SUBMITTAL IDENTIFICATION SHEET

WEBSTER UNIVERSITY ISB
PROJECT NAME

123553-001 REV 2
CONTRACTOR / CM SUBMITTAL NO.

COPIES	DATE	NO.	DESCRIPTION
1	1/25/17	04437AR1-E2 and 04337BR1-E4	Rough-In & Elevation Shop Drawings
1	1/25/17	04437DETAILS1 & 04437DETAILS2	Cabinet Sections
1	1/25/17	04437OHSC	OHSC detail/quantities Sheet
1	1/25/17	Set	Project Data Document

Drawing Number: WUIS-06

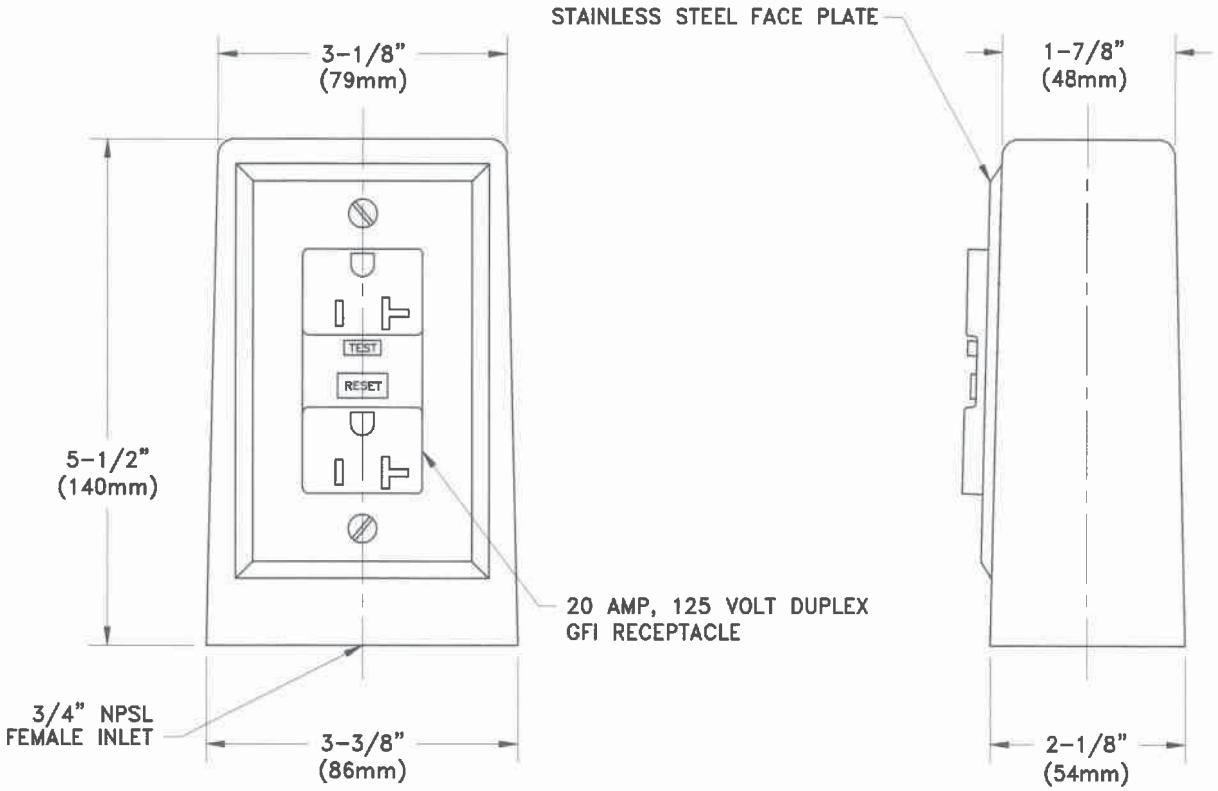
-COORDINATE ALL ELECTRICAL OUTLETS WITH ELECTRICAL DRAWING & SPECIFICATIONS. TECHNICAL SPECIFICATIONS PER ELECTRICAL DRAWINGS.
